# HISTORIC AND DESIGN REVIEW COMMISSION

**HDRC CASE NO:** 2024-249  
**ADDRESS:** 515 RIVERSIDE DR  
**LEGAL DESCRIPTION:** NCB 7649 BLK LOT 25  
**ZONING:** MF-33, H  
**CITY COUNCIL DIST.:** 3  
**DISTRICT:** Mission Historic District  
**APPLICANT:** Corbin Lomas  
**OWNER:** Hector Martinez/SAN ANTONIO HOUSING AUTHORITY  
**TYPE OF WORK:** New construction of a 1-story building and a pavilion  
**APPLICATION RECEIVED:** July 09, 2024  
**60-DAY REVIEW:** September 07, 2024  
**CASE MANAGER:** Rachel Rettaliata  
**REQUEST:**

The applicant is requesting a Certificate of Appropriateness for approval to:

1. Construct a new 1-story maintenance building on the northwest side of the property.
2. Construct a new approximately 734-square-foot pavilion on the west side of the property.

**12 EAVE DETAIL @ PAVILION**  
3/4" = 1'-0"

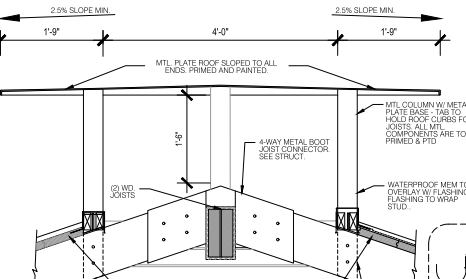
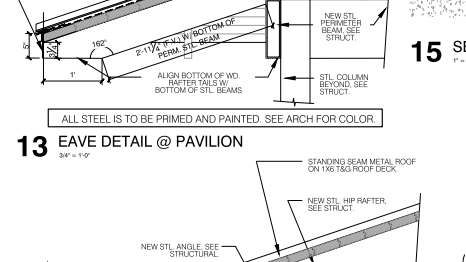
- j. PAVILION INSTALLATION – The applicant has proposed to construct an approximately 744-square-foot pavilion on the west side of the complex, adjacent to and north of the existing playground area, on a new concrete pad. The pavilion will be 15’-8 ¼” in height and will feature steel columns, steel beams, a standing

seam metal roof with an open cupola, and exposed wood rafters. Staff finds the proposal generally appropriate but finds that the standing seam metal roof should meet the standard specifications.

- iv. That the applicant installs a standing seam metal roof on the pavilion featuring panels that are 18 to 21 inches wide, seams that are 1 to 2 inches high, a crimped ridge seam, and match the current finish or a standard galvalume finish. Panels must be smooth without striation or corrugation. Ridges are to feature a double-munch or crimped ridge configuration; no vented ridge caps or end caps are allowed. All chimney, flue, and related existing roof details must be preserved. No modifications to the roof pitch or roof form are requested or approved at this time. An inspection must be scheduled with OHP staff prior to the start of work to verify that the roofing material matches the approved specifications.
